Model: Russian-C4	Date: 6-Sep-05	No.: RB205001n
-------------------	----------------	----------------

Subject: Firmware Release History (Controller)		Prepared by: S. Tomoe	
From: 2nd Tech Support Sec. Service Support Dept.			
Classification:	<input type="checkbox"/> Troubleshooting <input type="checkbox"/> Mechanical <input type="checkbox"/> Paper path <input checked="" type="checkbox"/> Other ()	<input type="checkbox"/> Part information <input type="checkbox"/> Electrical <input type="checkbox"/> Transmit/receive	<input type="checkbox"/> Action required <input type="checkbox"/> Service manual revision <input type="checkbox"/> Retrofit information

Model: Russian-C4		Date: 28-Sep-05	No.: RB205005
Subject: Rotate Sort		Prepared by: S. Tomoe	
From: 1st Tech. Support Sec. Service Support Dept.			
Classification:	<input checked="" type="checkbox"/> Troubleshooting	<input type="checkbox"/> Part information	<input type="checkbox"/> Action required
	<input type="checkbox"/> Mechanical	<input type="checkbox"/> Electrical	<input type="checkbox"/> Service manual revision
	<input type="checkbox"/> Paper path	<input type="checkbox"/> Transmit/receive	<input type="checkbox"/> Retrofit informat

[Screw location]

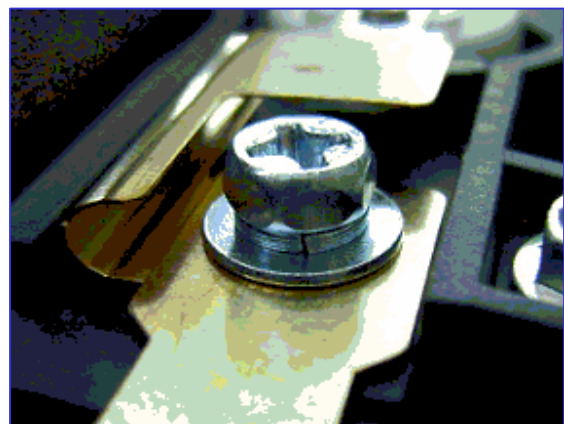
SC542 may occur when the main power is turned on or the machine recovers from AOF mode.

Visit the customer sites of the “**Affected Units**” listed below, and check the condition of the screws. If the screws were inserted incorrectly as described above, replace the fusing unit.

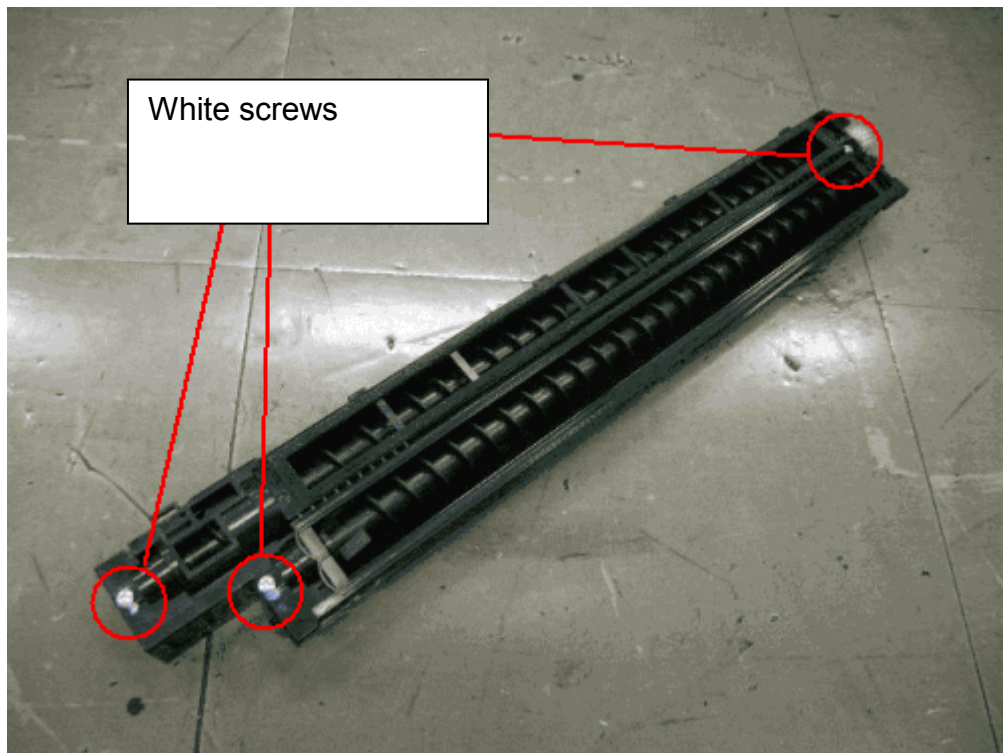
From February 2007 production of R-C4/C4.5 mainframes, the screws of the PCU are painted white (see the next page). Therefore, when you replace the PCU in the field, **do not loosen or remove these screws.**

PCU with screws painted white (from Jan. 2007 R-C4/C4.5 production)**Do not** loosen or remove these screws.

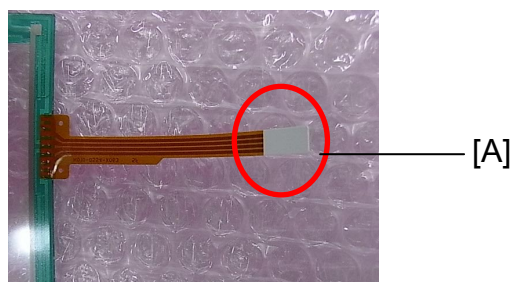
Note: Visual difference between the old and new touch panels:

Old (B2135222): The tip [A] of the electrode attached to the touch panel is **brown**.

New (H3106173): This tip [A] is **white**.

IMPORTANT: Therefore, if the tip [A] is white, do not replace the touch panel.

How to distinguish the new parts from the old parts

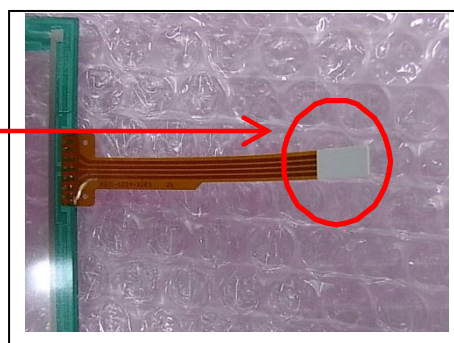
Old parts:
The tip of the electrode is **brown**.

New parts:
The tip of the electrode is **white**.

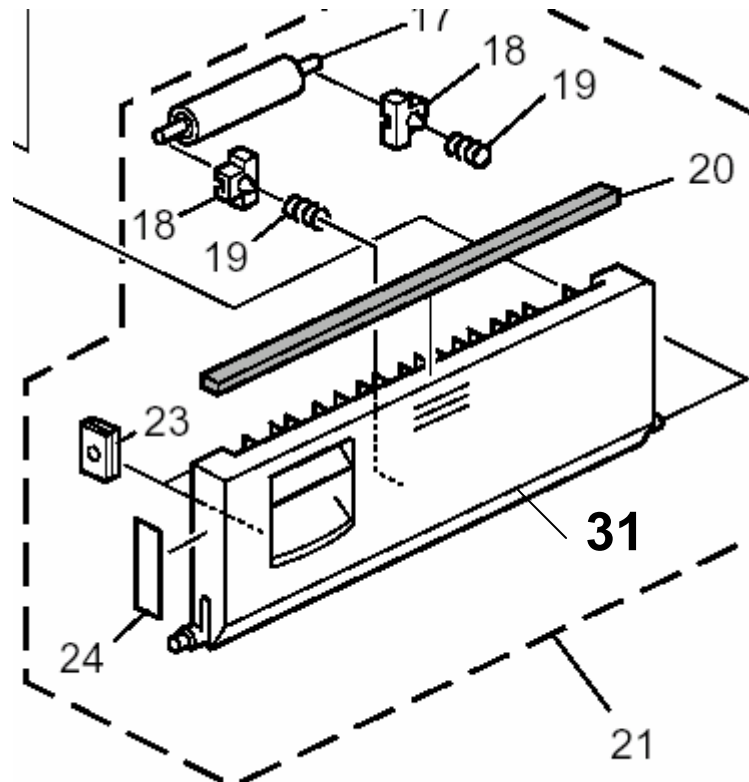
The following part was newly added as per field request:

Old part number	New part number	Description	Q'ty	Int	Page	Index	Note
	B0902738	Cover: Vertical Transport	0-1		27	31
